February 9, 2022

Re: The Downs - Preliminary Site Plan, Additional Items, Engineering aspects
OHM Job No. 0152-21-1020

Preliminary Site Plan Additional Item Engineering Comments

Groundwater observation
from Soil Investigation Report by
McDowell & Associates

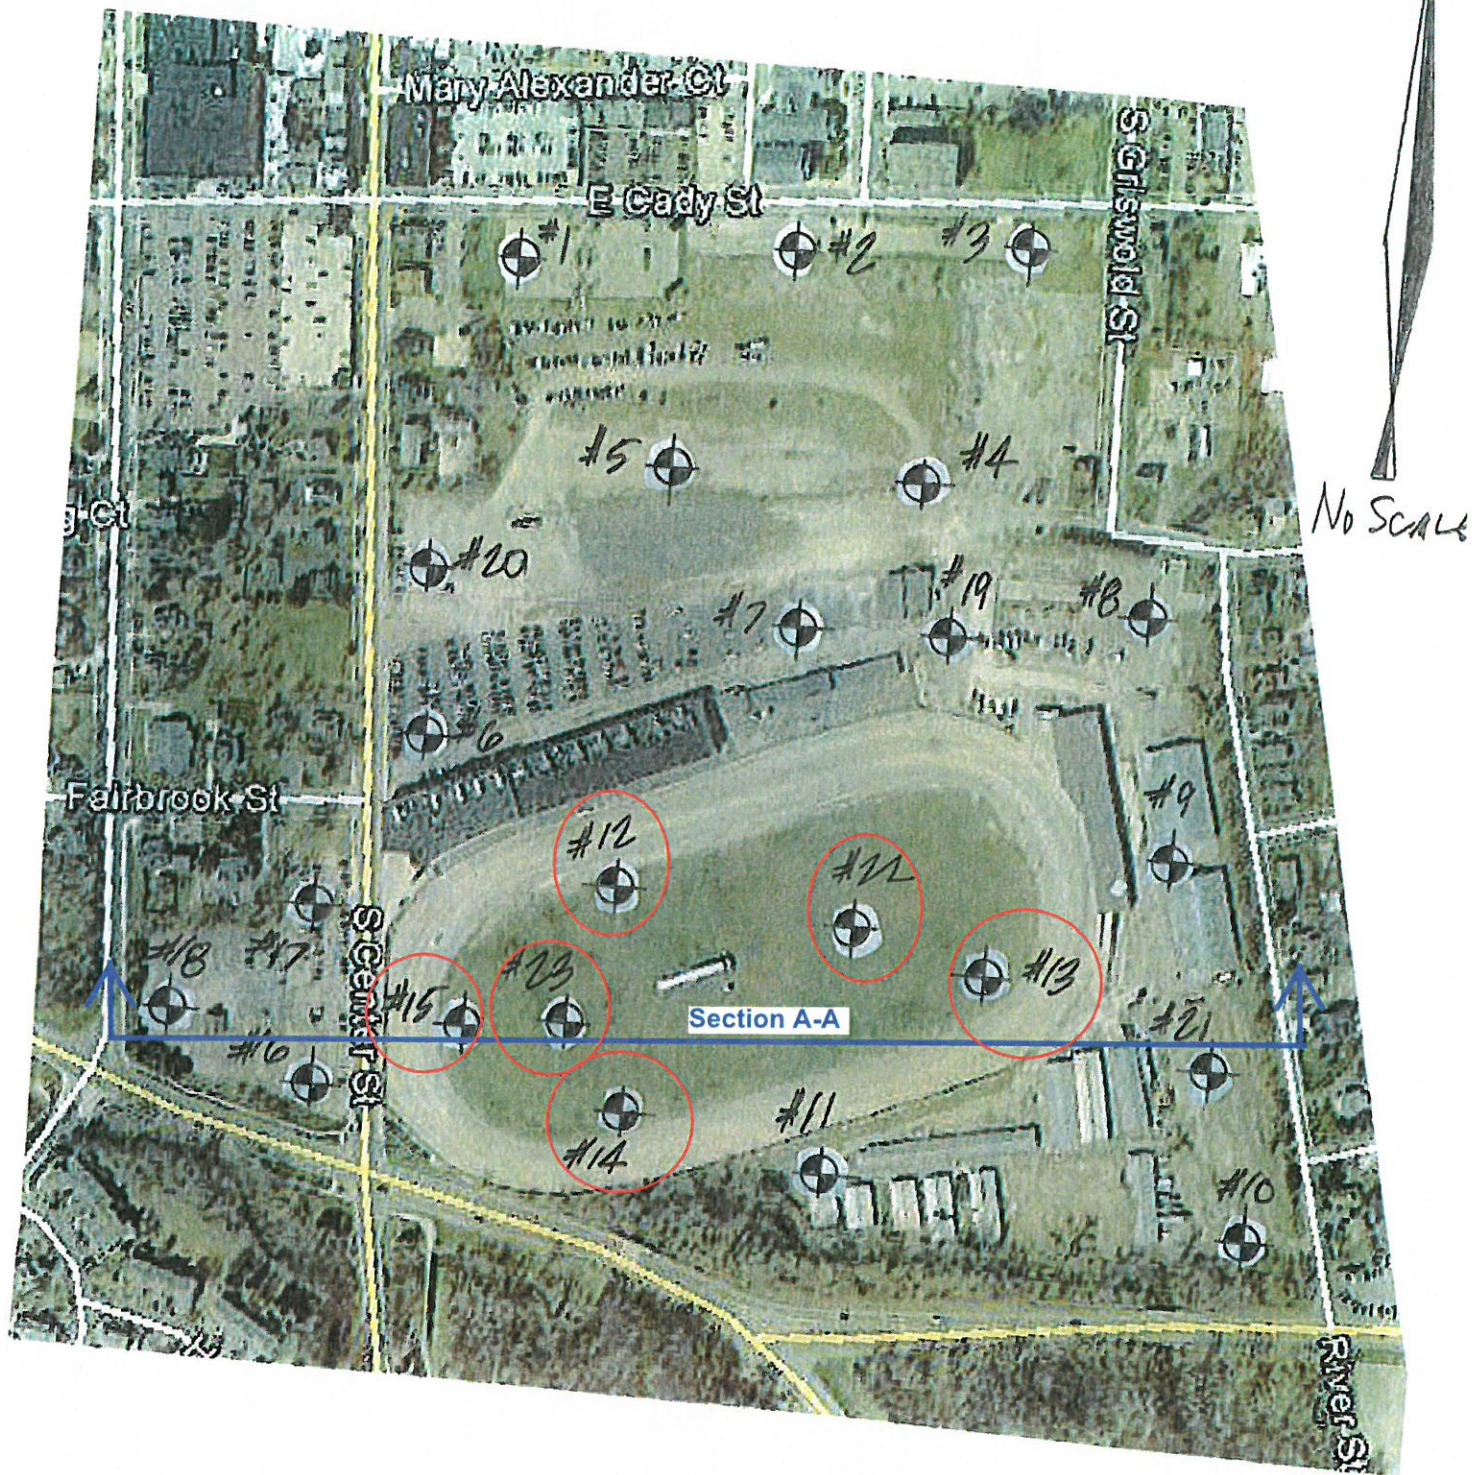
2. **Site groundwater elevation in the lower portion of the development impacting proposed housing unit types.** We have reviewed the McDowell Geotechnical report dated March 16, 2018, and compared that to the currently proposed finish grade elevations for the building units in this area of the development. We supplemented the similar comparison prepared by Don Webb and submitted to the PC in the Feb 2 PC agenda package. Based on current information provided, it appears there is a very little vertical separation between the proposed FG minus a 12 ft basement excavation depth

(10 ft basement, 1 ft footing, 1 ft separation from GW) and the observed groundwater elevation, as documented during the soil boring activity of March 8th and 12th, 2018. This supports the applicants proposed housing unit type to multi-family with no basement where exiting ground water depth is shallow relative to existing surface. Groundwater elevations are variable but typically they are at higher elevations in the early spring and late fall. Given the timing of observation, the groundwater elevation in March should be suitable for this assessment, although we recommend that the Applicant's Geotechnical Consultant install piezometers in this southern area to allow for further tracking of the seasonality and variability of the groundwater elevation.

OHM Mark Ups based on desired basement depths
